Access Compliance Report

Public Rights-of-Way

(Curb Ramps)

Intersection ID: 52453	Main Street: PAT_GARRETT_ST	Cross Street: DOUBLE_OAKS_RD	Location: SE
ADA ID: BBADA46923DC	Ramp Type: Directional1	Initial Pass/Fail: Pass	Overall Compliance: No
Severity Score: 20.25			
Codes/Mitigation Info/Possible Solution		Field Measurements/Component Compliance

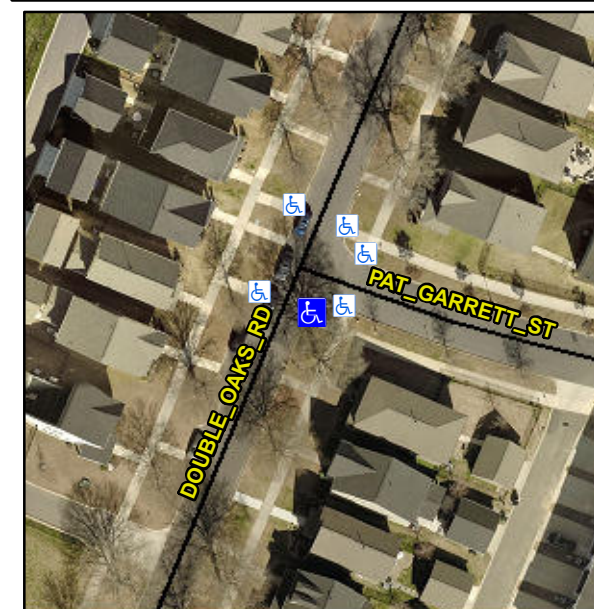
R304.5.3, R302.7.2, R304.5.4

Compliance	Description	Data	Compliance	Description	Data
N/A	Ramp Length (in)	80.0	Yes	Grade Break?	Yes
Yes	Ramp Width (in)	66.0	No	Grade Break Slope (%)	6.0
Yes	Ramp Slope (%)	6.2	No	Grade Break XSlope (%)	2.8
No	Ramp XSlope (%)	3.2			
Yes	Flare Type LT	N/A	Yes	Flare Type RT	N/A
N/A	Flare Slope LT (%)	N/A	N/A	Flare Slope RT (%)	N/A
N/A	Flare Traversable LT?	No	N/A	Flare Traversable RT?	No
Yes	Landing Length (in)	72.0	Yes	DWS Provided?	Yes
Yes	Landing Width (in)	72.0	Yes	DWS Contrast?	Yes
Yes	Landing Slope (%)	0.5	Yes	DWS Length (in)	24.0
No	Landing X Slope (%)	3.6	Yes	DWS Full Width?	Yes
N/A	Landing Curb? (Y/N)	N/A	Yes	DWS Offset LT (in)	1.0
N/A	Shared Landing?	Yes	Yes	DWS Offset RT (in)	16.0
Yes	Gutter Ponding?	No	No	Gutter Slope (%)	6.5
No	Gutter Lip Ht (in)	1.0	No	Gutter X Slope (%)	3.5
N/A	Painted X Walk1?	No		Road Slope (%)	2.9
	X Walk 1 Direction	To W		Road X Slope (%)	1.9
	X Walk 1 Width (in)	N/A		Clear Space?	Yes

X Walk 1 Slope (%)	2.9	N/A	Clear Space to XWalk (in)	N/A
	X Walk 1 X Slope (%)	1.9	Yes	Storm Grate/Utility Hazard?	No
N/A	Ramp inside XWalk1?	N/A		Storm Grate/Utility Type	
Yes	Any Obstructions?	No			N/A
	Obstruction Type		Yes	Surface Condition? (G/P)	Good
			N/A	Curb Slope (%)	1.9

**Remove & Replace Entire Ramp.
Remove & Replace Gutter.**
